NORTH CENTRAL HIGH SCHOOL, PHASE 2

Addendum 5

**NORTH CENTRAL HS
CAFETERIA/COMMONS ADDITION**

ADDENDUM 5

CA-20

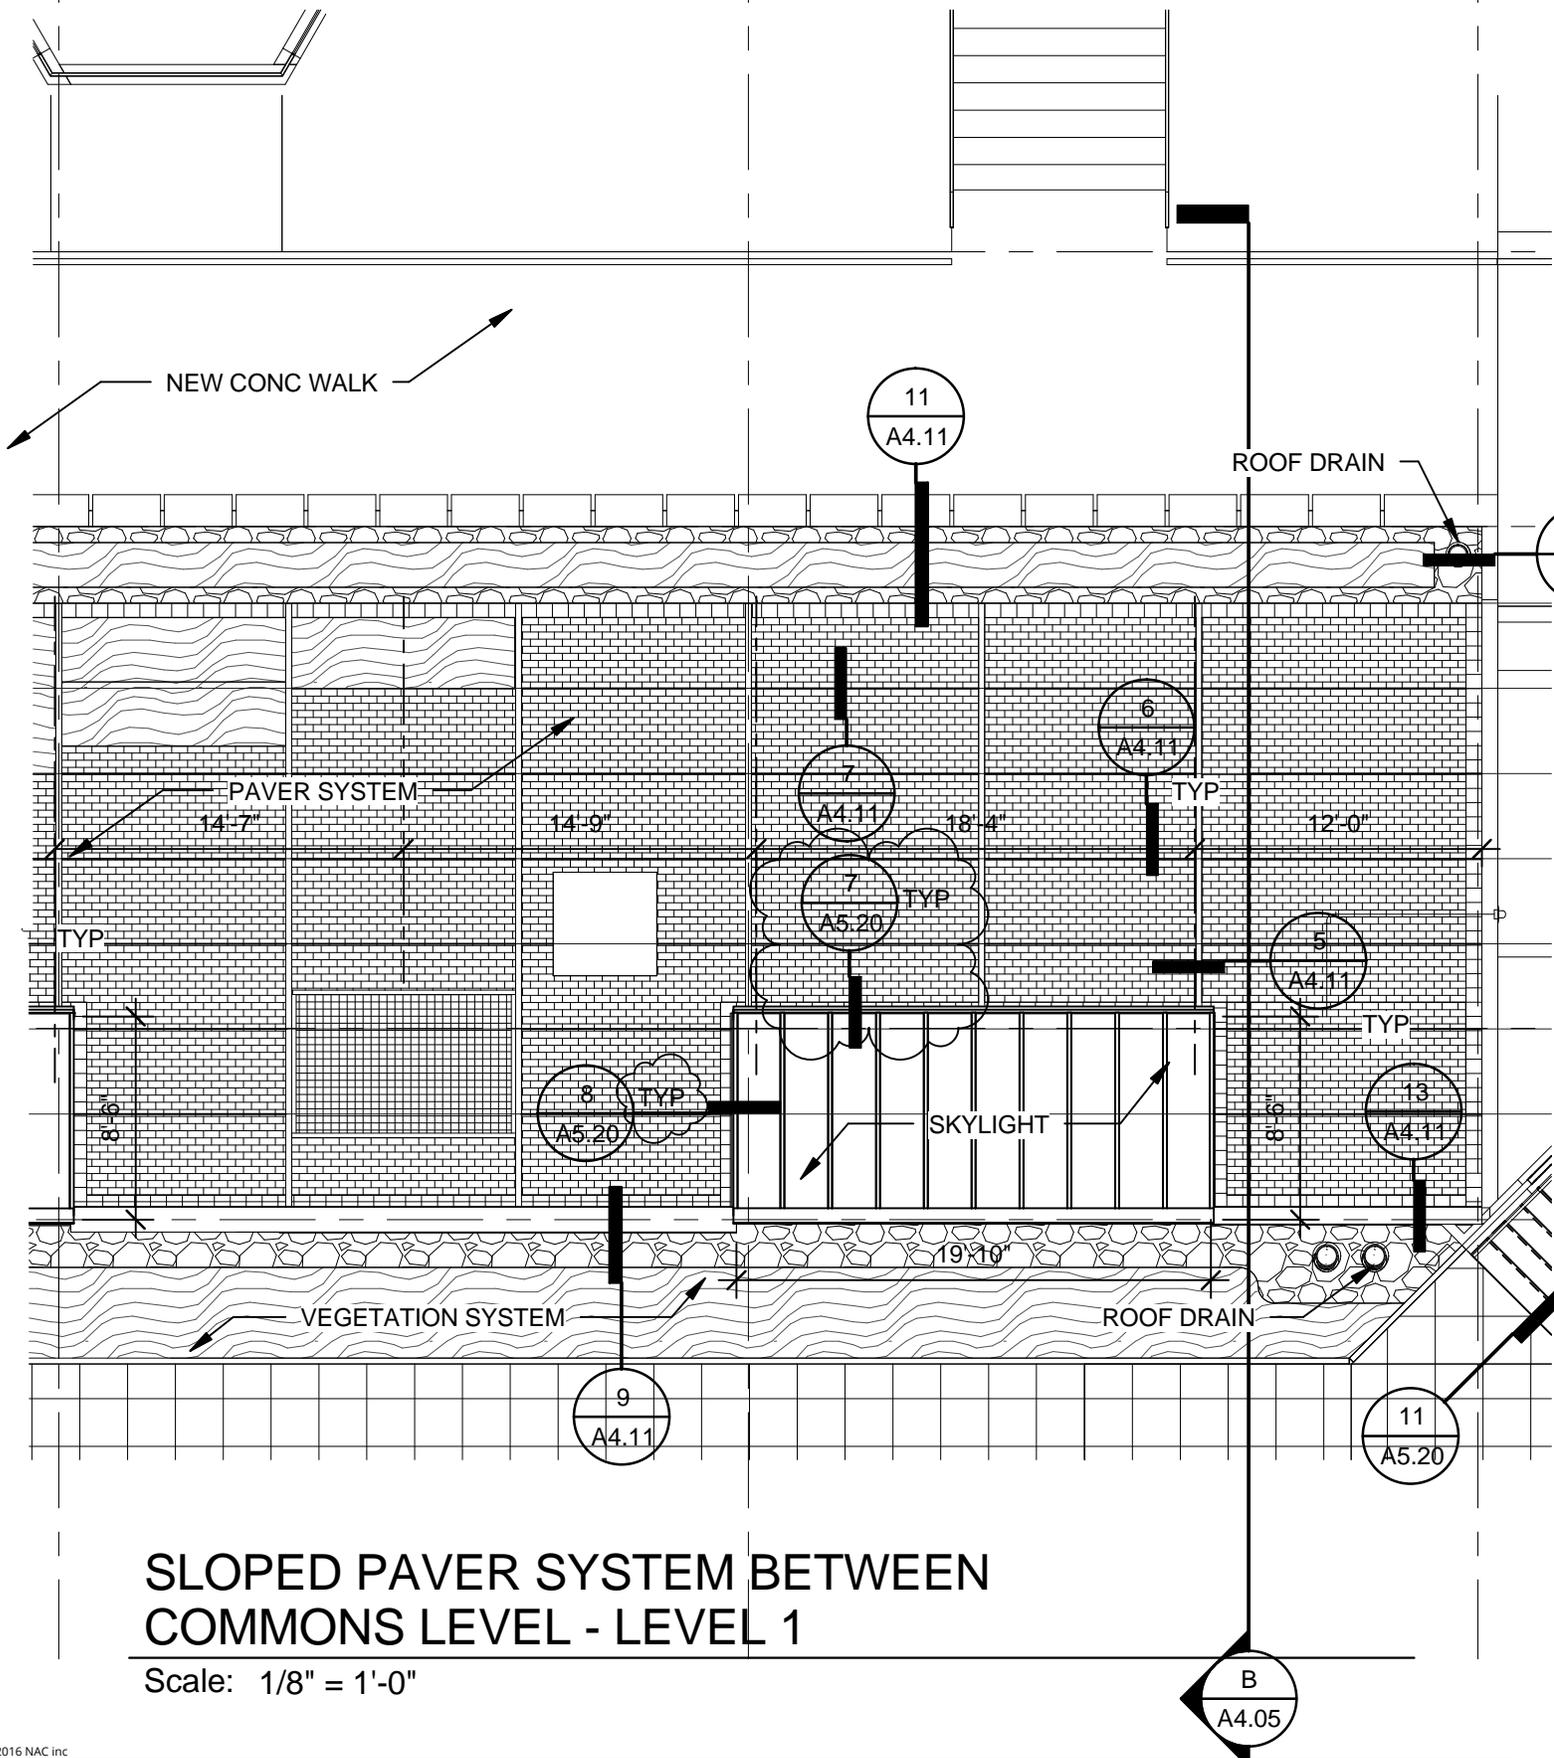
31
32 SHEET A4.11, BELOW PAVER ROOF PLAN – COMMONS LEVEL

33 **CHANGE** the SLOPED PAVER SYSTEM BETWEEN COMMONS LEVEL – LEVEL 1 plan per the
34 attached clarification drawing CA-20.
35
